**CITY OF MERIDIAN
FINDINGS OF FACT, CONCLUSIONS OF LAW
AND DECISION & ORDER**

Case No(s). H-2025-0004

COMMUNITY DEVELOPMENT
DEPARTMENT REPORT

HEARING DATE: 3/10/2026
TO: Mayor & City Council
FROM: Nick Napoli, Associate Planner
208-884-5533
Nnapoli@meridiancity.org
APPLICANT: Jason St. George
SUBJECT: H-2025-0004
St. George

DESIGNED BY J. MATHEWS	SUB SHEET NO. C1.0	TITLE OF SHEET OVERALL LAYOUT TOPAZ DEVELOPMENT	DATE AUGUST 2025
DRAWN BY T. COOK			PROJECT NO. 1924-093
CHECKED BY J. CHRISTENSEN			SHEET 5 OF 10
DATE 2/19/2026		MERIDIAN, IDAHO

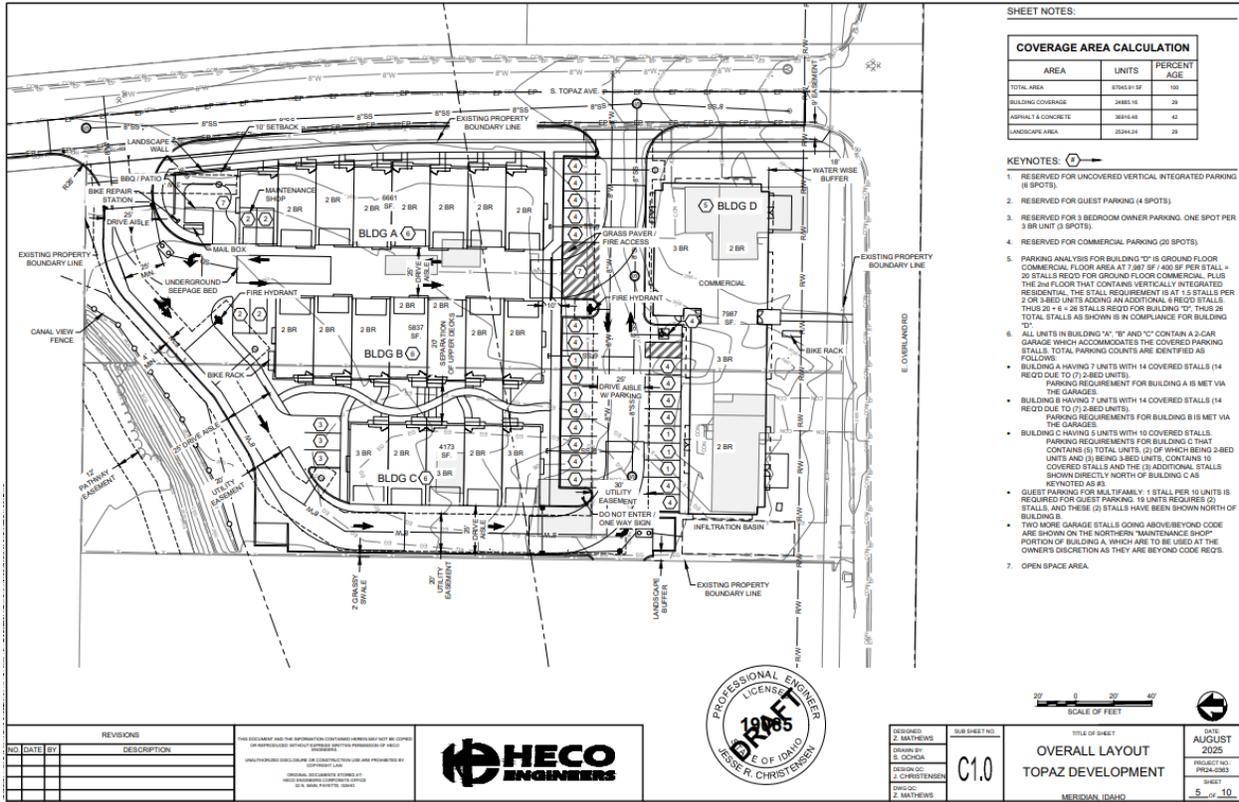
— **The multifamily buildings do not meet the 80 square feet of private usable open space for the residences to use in the multi-family portion of the property. Currently, they are proposing 68 square feet, below the requirement in the UDC.**

— **Water main placement on the west side does not meet the required 4' setback from the curb; inadequate separation from the infiltration trench; fire hydrants not shown, raising easement and spacing concerns; easement area limits the ability to meet landscaping and tree requirements.**

— **Proposed balconies/porches may encroach into 20' sewer easement; landscaping within the easement is not allowed, preventing compliance with UDC 11-3B-12.**

1. The site and landscape plan shall include the following revisions:
 - Depict all proposed fencing and provide a fencing exhibit.
 - Implement directional signs and striping to indicate the northern entrance off of Topaz Avenue as one-way.

- Provide parking lot landscaping in accordance with UDC 11-3B-8 or apply for alternative compliance to relocate the trees to the buffer along Overland Road.

- Provide bicycle parking for the multi-family and non-residential uses in compliance with UDC 11-3C.
 - Leave Five Mile Creek in its natural state and remove the northernmost unit in Building A to incorporate additional open space, and relocate the three (3) amenities, one from each category, be relocated to the open space south of Five Mile Creek.

7. Show accessible pedestrian routes from the buildings to the pathway. Parallel parking on the north side of Building B appears to block pedestrian access to pathway and open space amenity.
